INTERIOR ALTERATION FOR 7 RESIDENTIAL UNITS, INCLUDING MEP WORK, IN EXISTING 3 STORY BRICK BUILDING WITH BASEMENT, 7 RESIDENTIAL UNITS (2 RESIDENTIAL DU COACH HOUSE NIC) AS PER PLANS AT: 2655 W HADDON AVE.

**TITLE SHEET
SITE PLAN & NOTES**
2655 W HADDON AVE
CHICAGO, IL 60622

CORRECTIONS TO PERMIT #100804598,
 INTERIOR ALTERATION FOR 7 RESIDENTIAL UNITS, INCLUDING MEP WORK,
 IN EXISTING 3 STORY BRICK BUILDING WITH BASEMENT, 7 RESIDENTIAL
 UNITS (2 RESIDENTIAL DU COACH HOUSE NIC) AS PER PLANS
 AT: 2655 W HADDON AVE.

CORRECTIONS AND RESPONSES:
 2655 W HADDON AVE.
 100804598

P-1

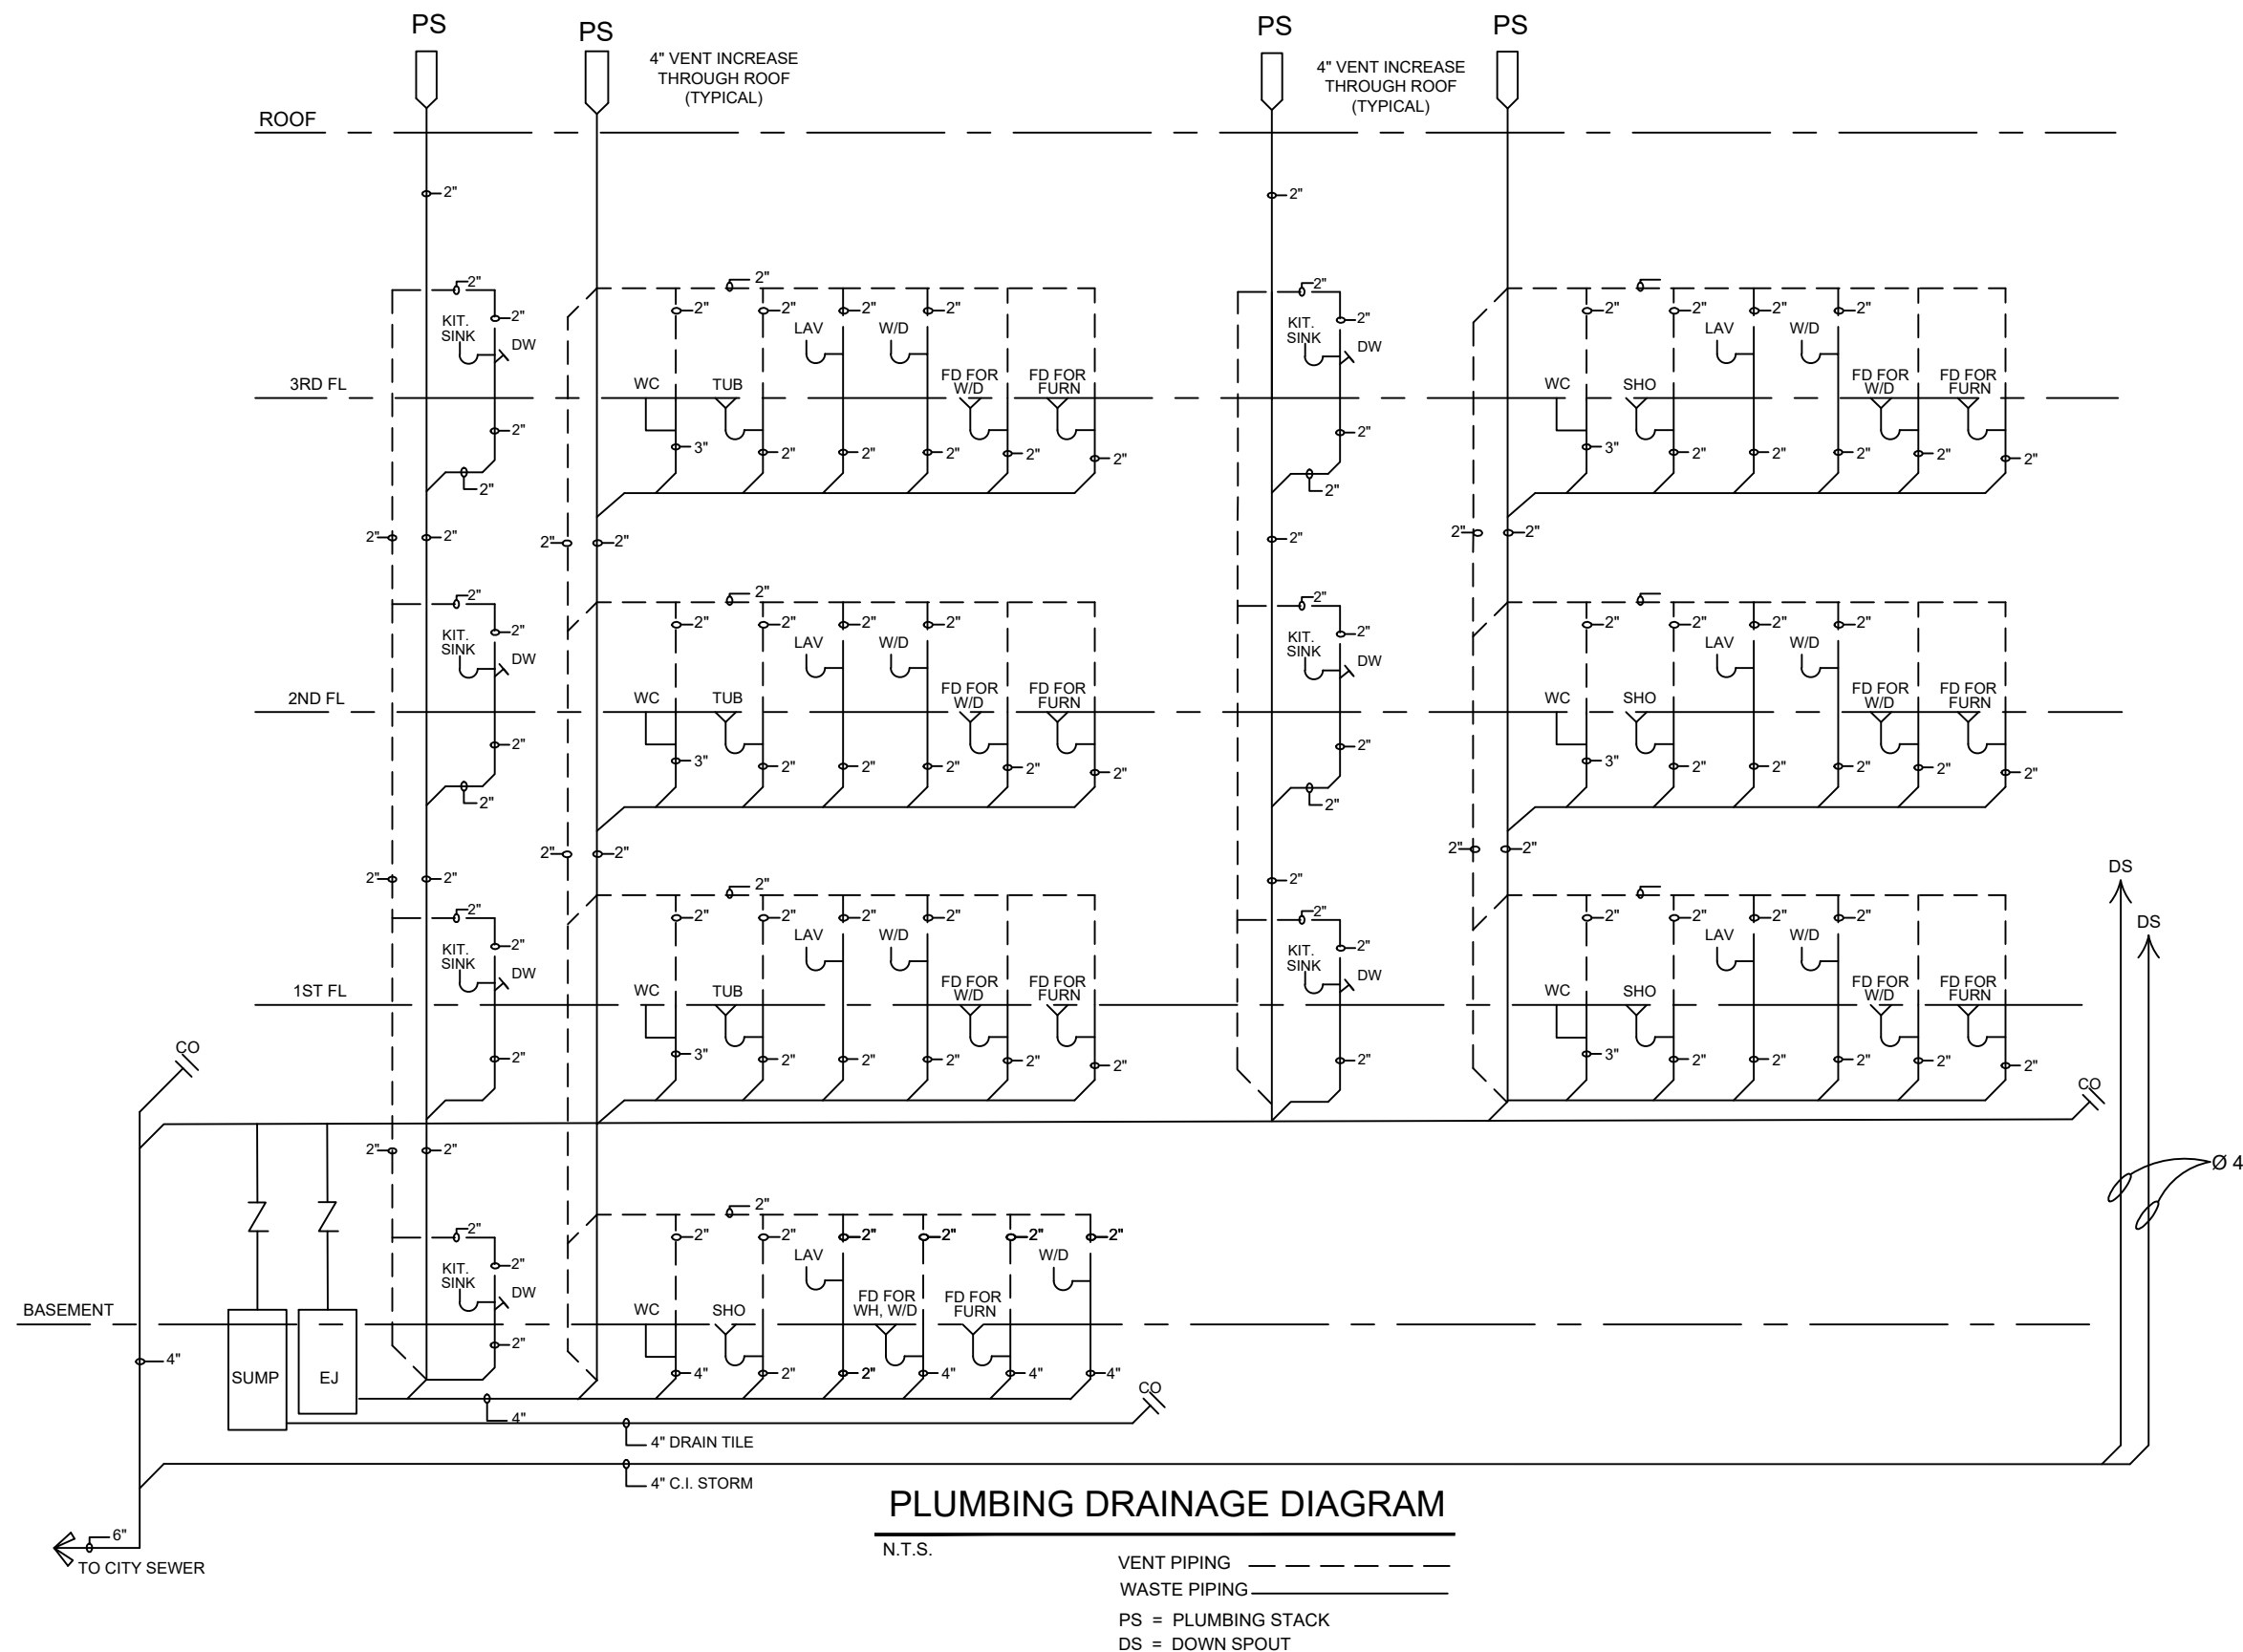
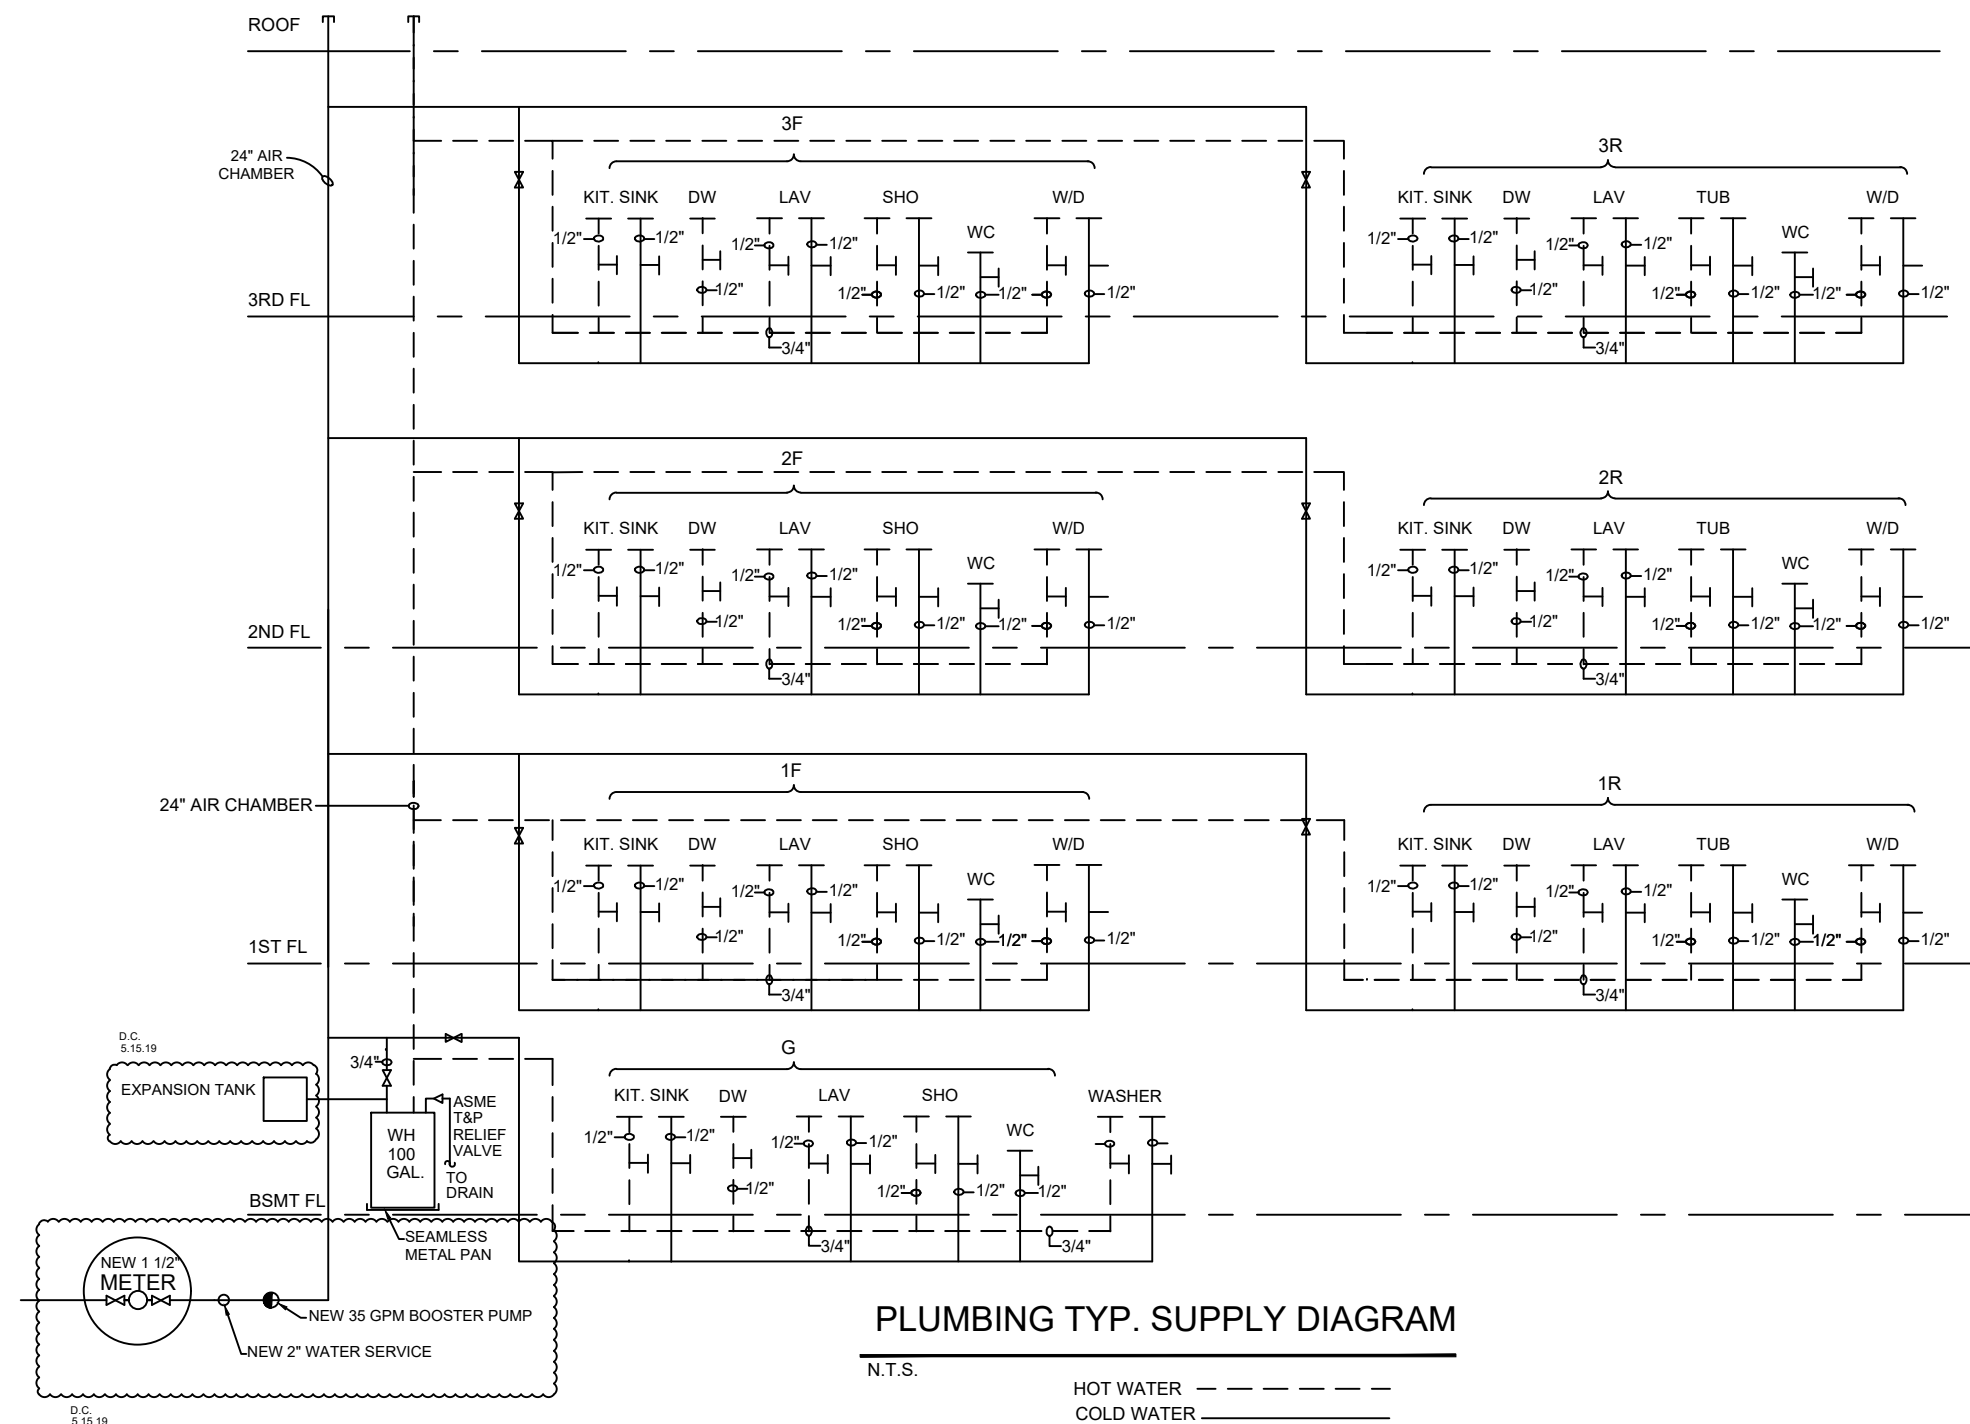
PLI2311 INSTALL 2 INCH WATER SERVICE WITH 1/1/2 MTR WITH R@R.
RESPONSE: PLEASE SEE NEW SERVICE AND METER SIZE ON P-1 SHEET.

PLI2311.....INSTALL 35 GPM BOOSTER PUMP.
RESPONSE: PLEASE SEE NEW BOOSTER PUMP ON SUPPLY DIAGRAM, P-1 SHEET.

PLI2311.....INSTALL EXPANSION TANK ON INLET SIDE OY WATER HEATER.
RESPONSE: PLEASE SEE NEW EXPANSION TANK ON P-1 SHEET.
